Springfield Township Library Renovation: Contractor Inquiry List **Addendum #2**

SUBJECT: MEP Bid Addendum #1 Narrative

SPFLD00611 - LIBRARY BUILDING RENOVATIONS
70 POWELL ROAD, SPRINGFIELD, PA 19064

M400

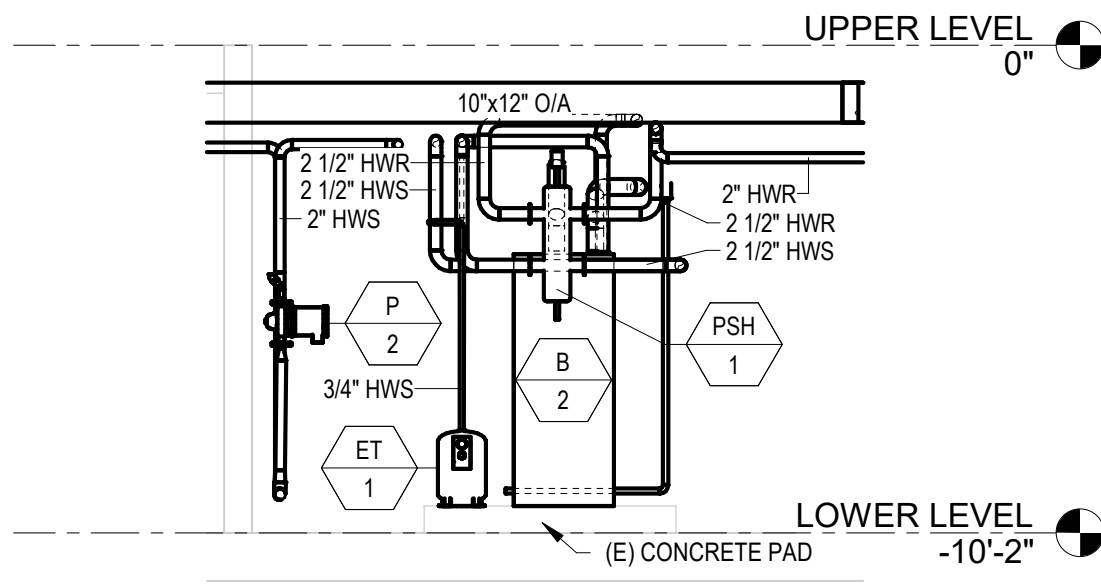
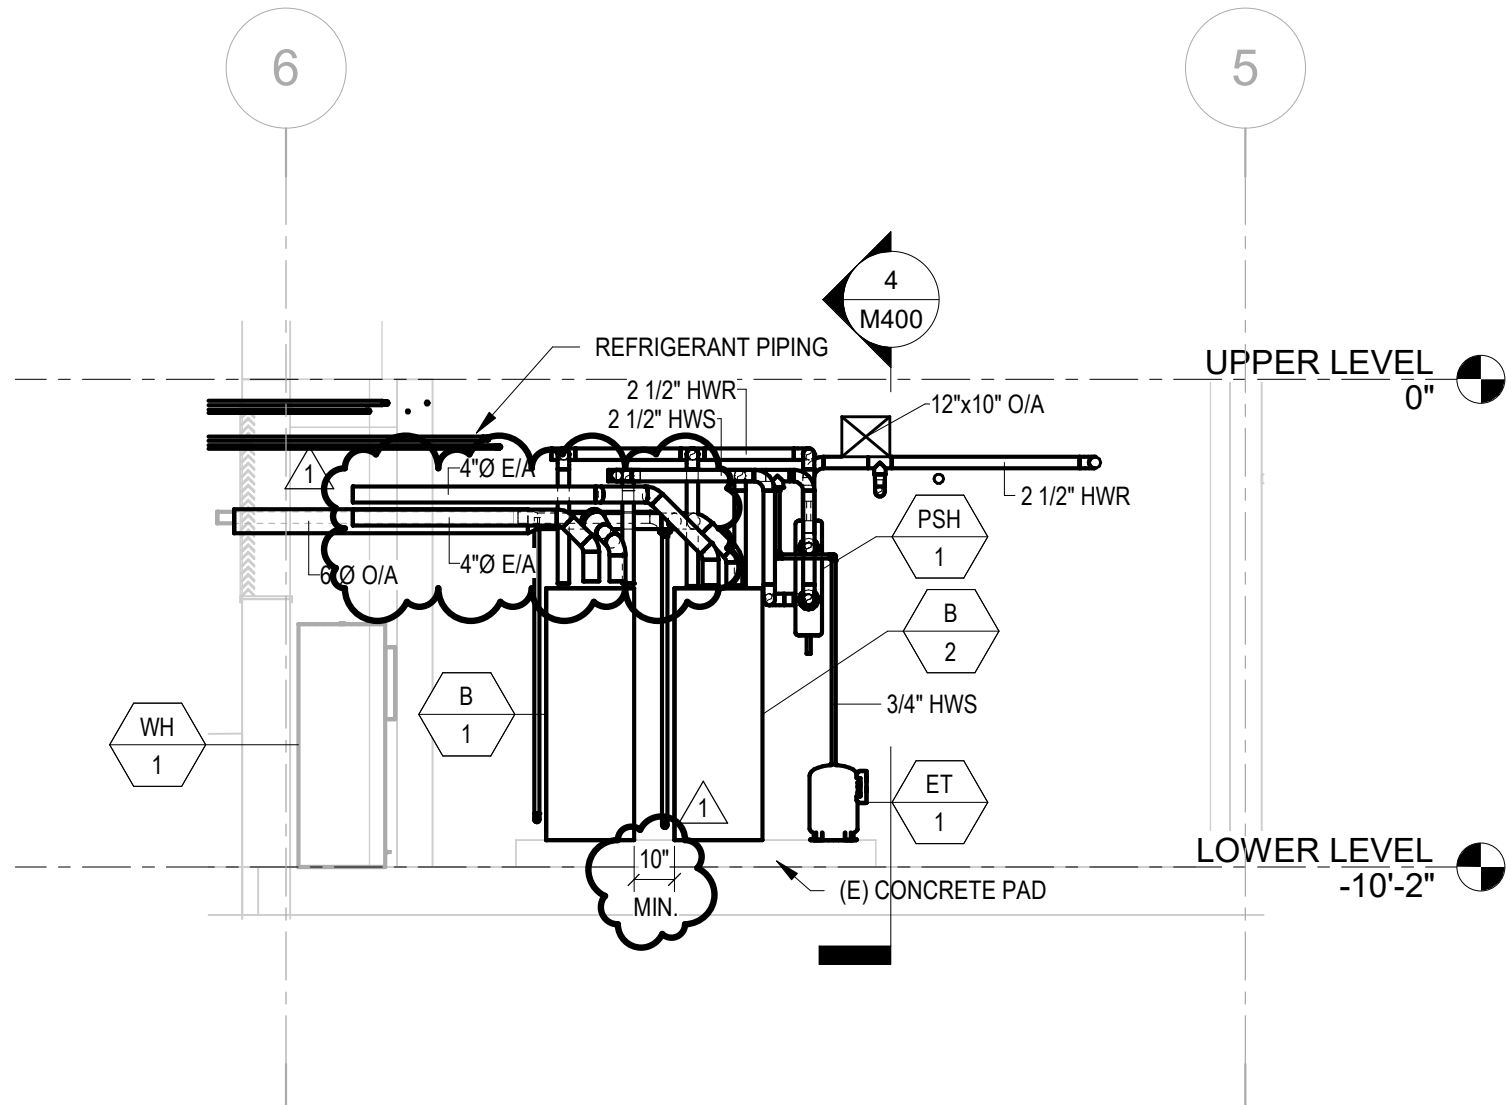
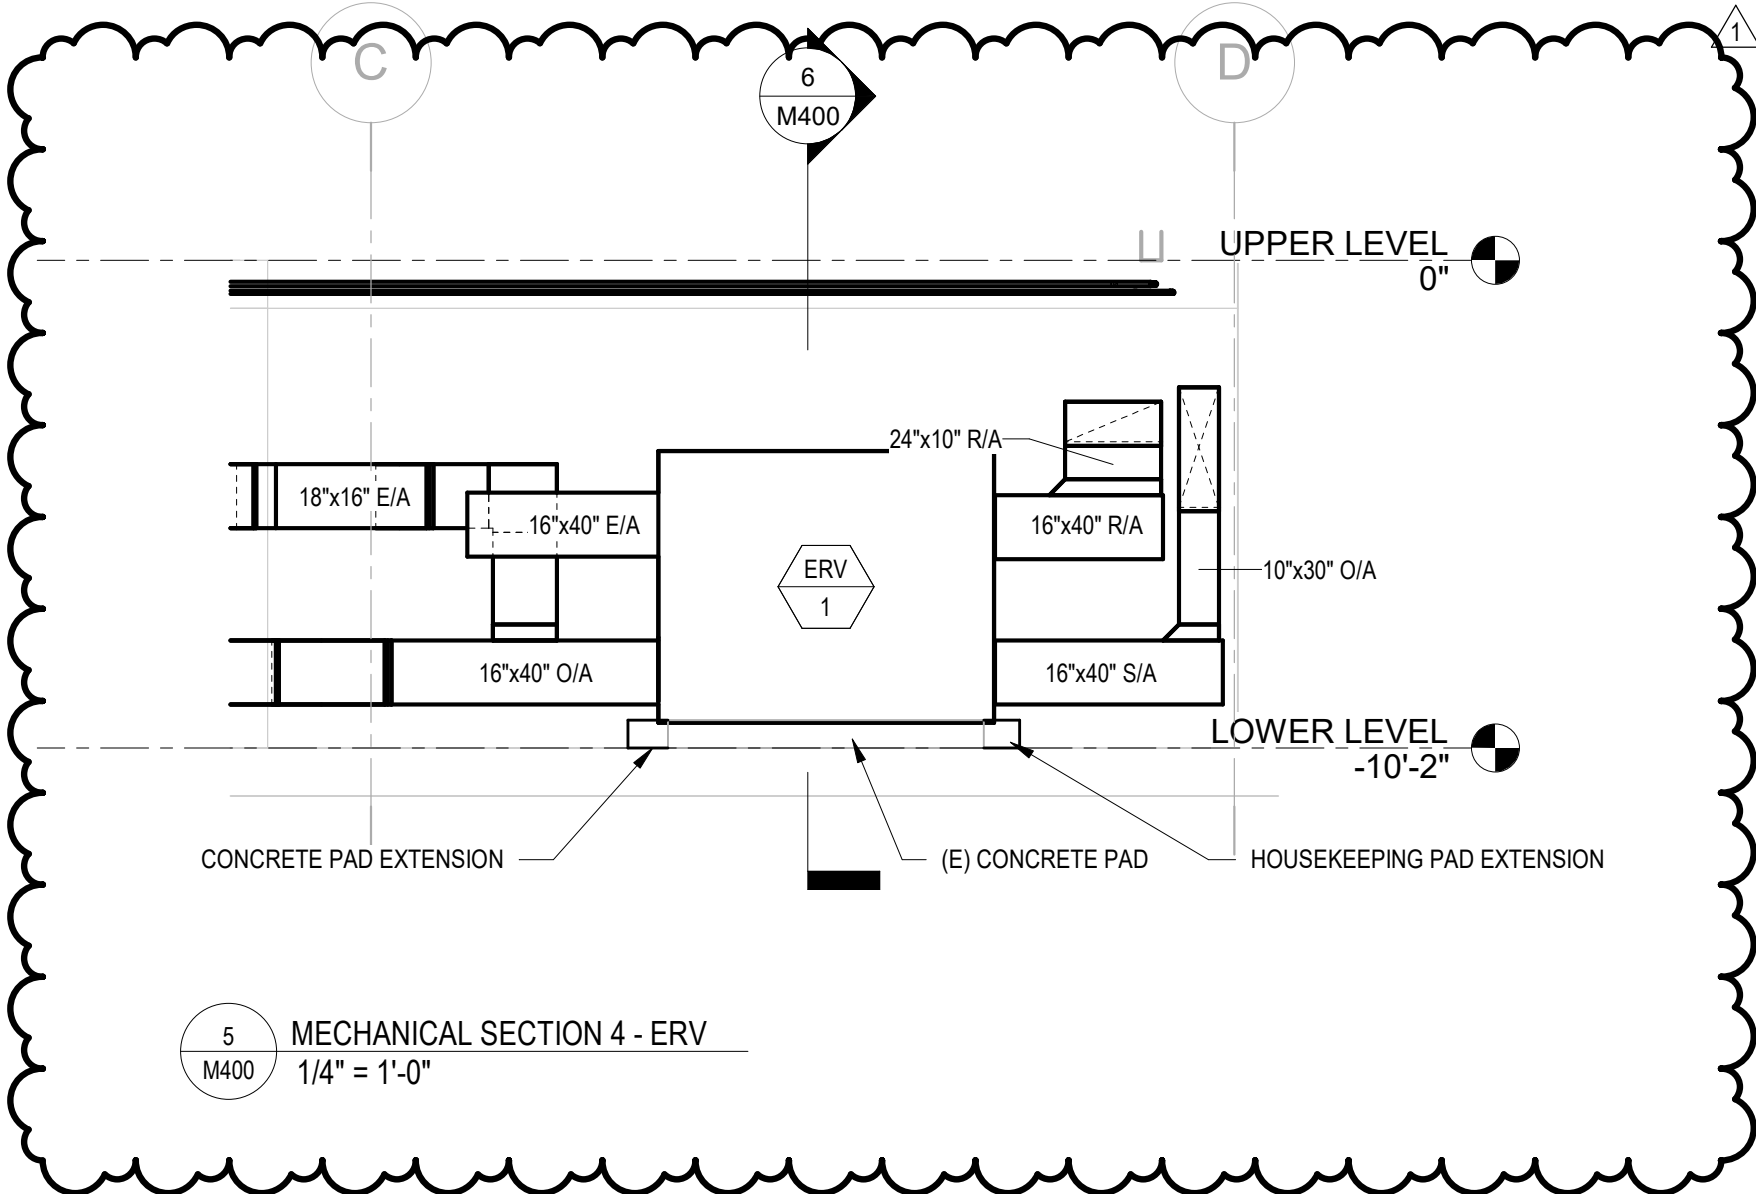
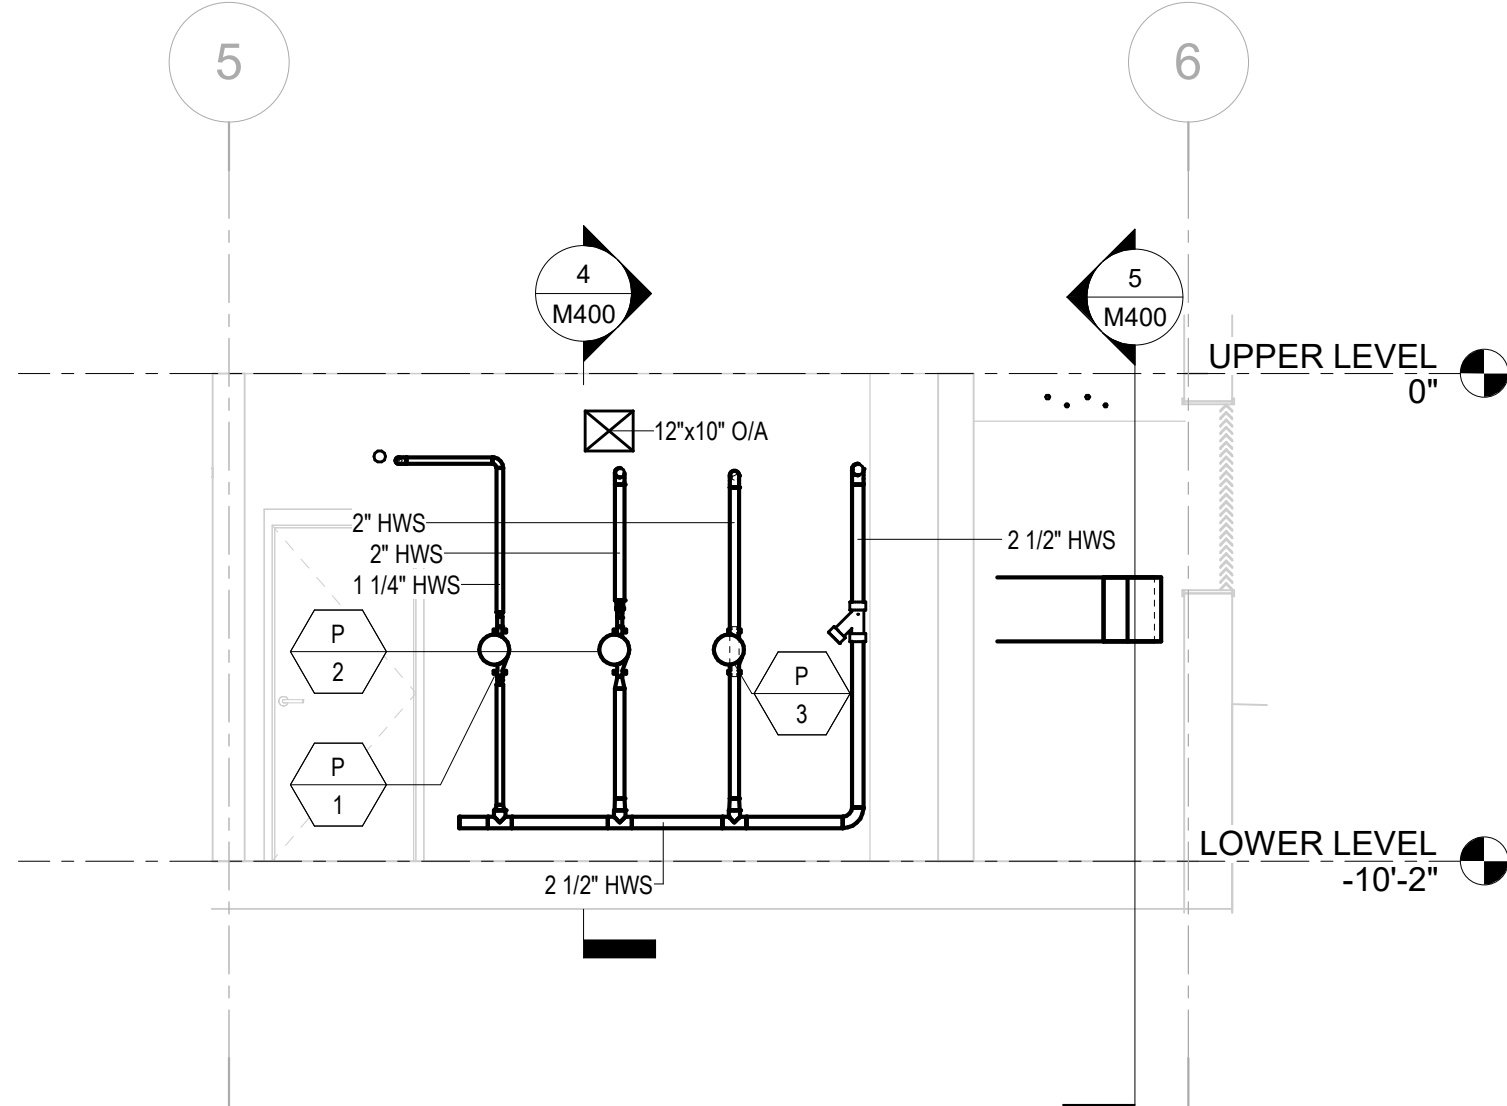
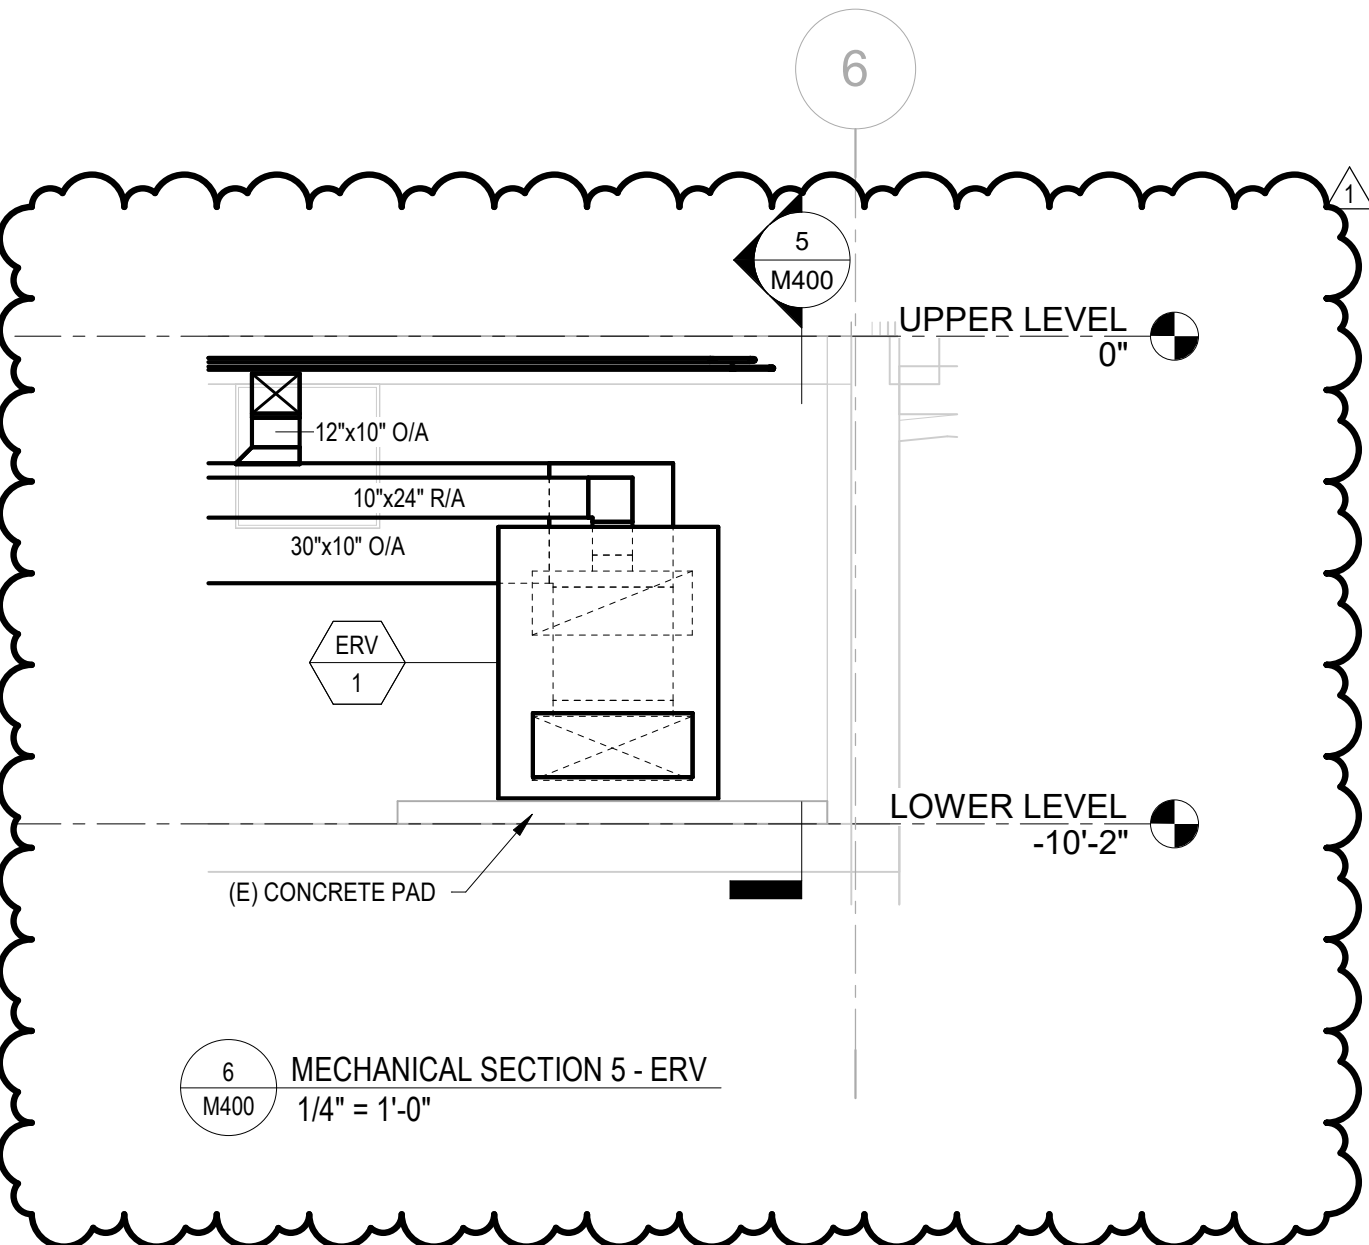
1. Added 1" bypass valve and piping on HWS/R branch lines.
2. Re-sized HWR piping to 2".
3. Revised boiler venting to be individual. This comes with the removal of backdraft dampers.
4. Clarified manufacturer clearances between boilers.
5. Added ERV sections for clarity.
